American Telecommunications Certification Body Inc.
6731 Whittier Ave, McLean, VA 22101

RE: Palmone Inc.

FCC ID: O8FMADECA

After a review of the submitted information, I have a few comments on the above referenced Application.

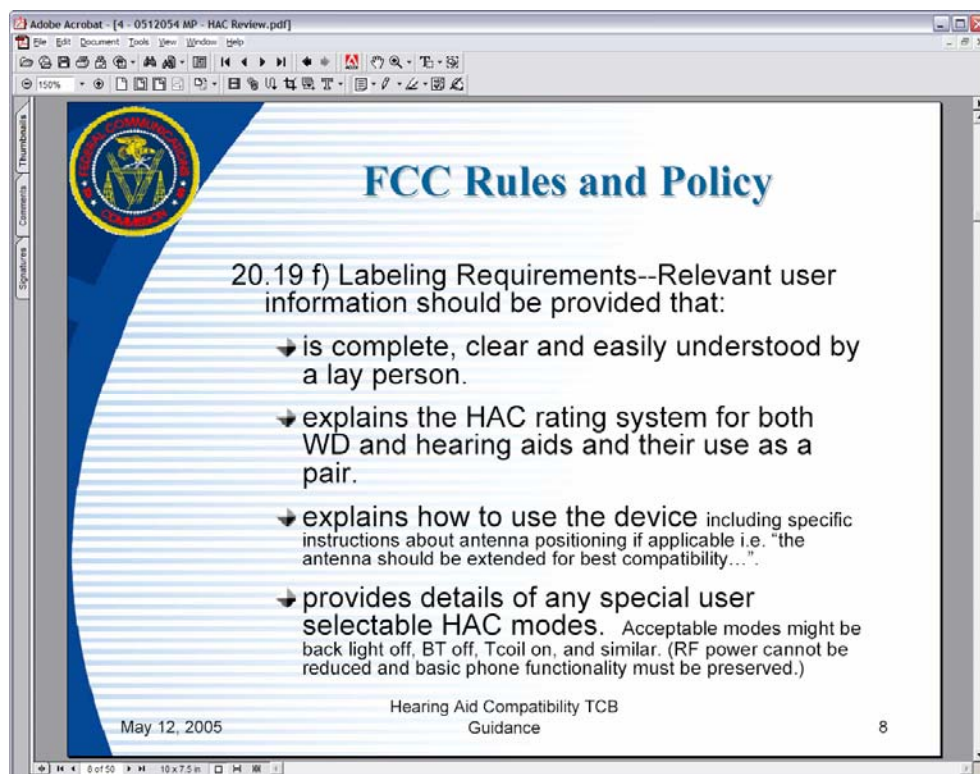
- 1) What kind of users information is provided to the user regarding HAC (i.e. manual, insert, packaging material, etc.) for compliance to 20.19(f). Please note the following from the FCC:

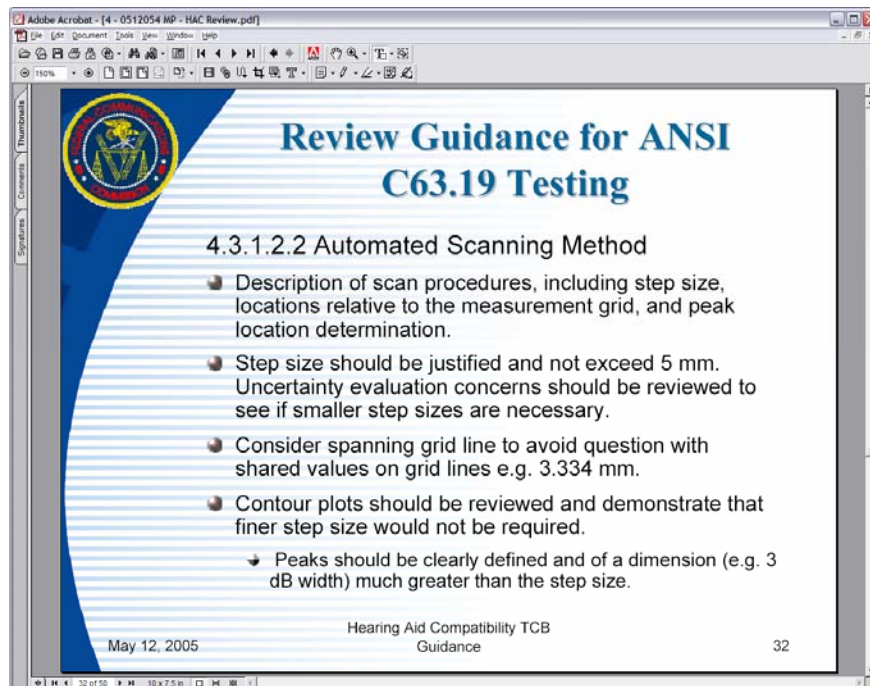
- 4) Test report should cite compliance to 20.19 according to 2.1033(d) of the rules:
2.1033(d)
Applications for certification of equipment operating under part 20, that a manufacturer is seeking to certify as hearing aid compatible, as set forth in §20.19 of that part, shall include a statement indicating compliance with the test requirements of § 20.19 and indicating the appropriate U-rating for the equipment. The manufacturer of the equipment shall be responsible for maintaining the test results.

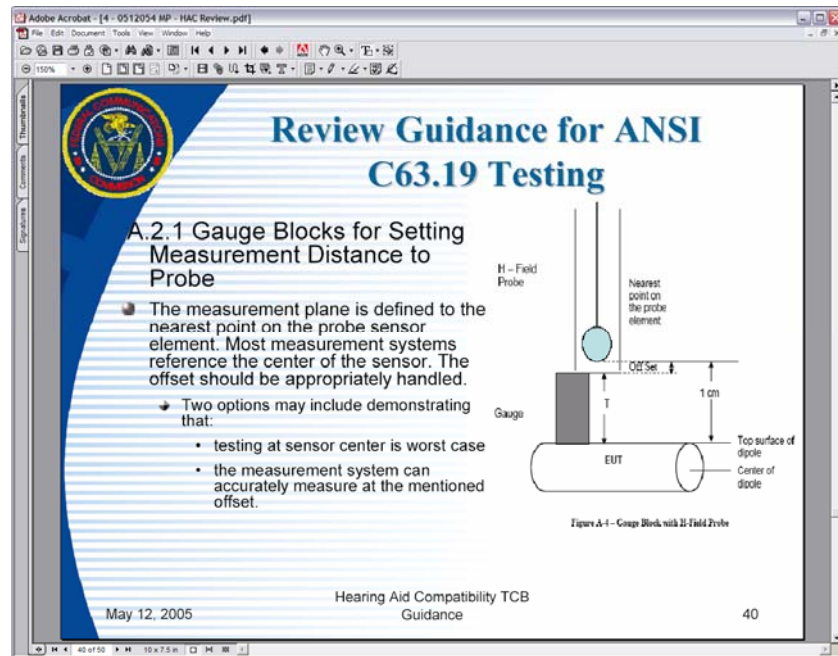
- 16) RF test procedures appear to be for clause 4, but the flow chart appears to be for Clause 6 data. Please review/explain/correct as necessary.
- 17) Scan procedures do not support enough detail. For instance the procedures should clarify the information shown in the slide below from FCC training. Additionally, the contours on many plots suggest that maybe a smaller step size should have been used. Please adjust the test report or comment on the items given in the follow slide:

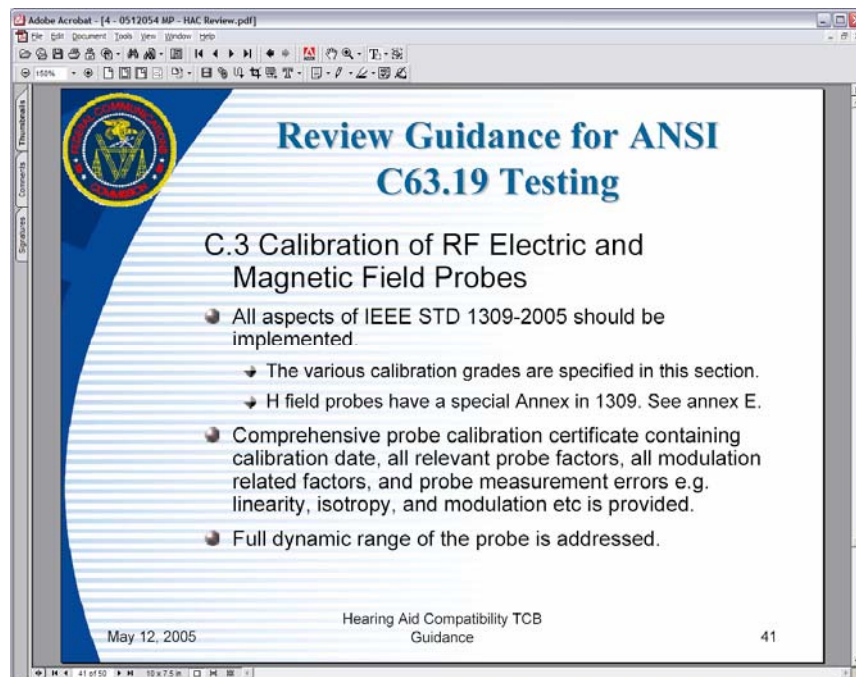
- 18) Please justify probe measurement at the center of the sensor. C63.19 recommends measurement at the nearest element point. Please include additional illustrations of the probe/elements showing more detail of the probe tip area. This is for compliance of information shown in the following slide:
